Access Compliance Report Public Rights-of-Way (Curb Ramps)

Main Street: SHAKESPEARE_DR Cross Street: MARTHA_ANN_DR Location: S

ADA ID: RPAT211201103657 Ramp Type: Type 1 - Perpendicular Diagonal Initial Pass/Fail: Fail Overall Compliance: No Severity Score: 15

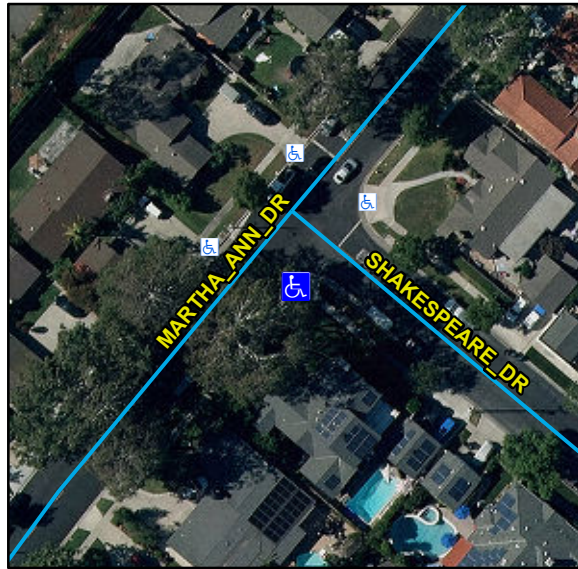
R204.3, R304.2.2, STD 1115

Remove & Replace Curb Ramp With Two New Directional Ramps or Equivalent.
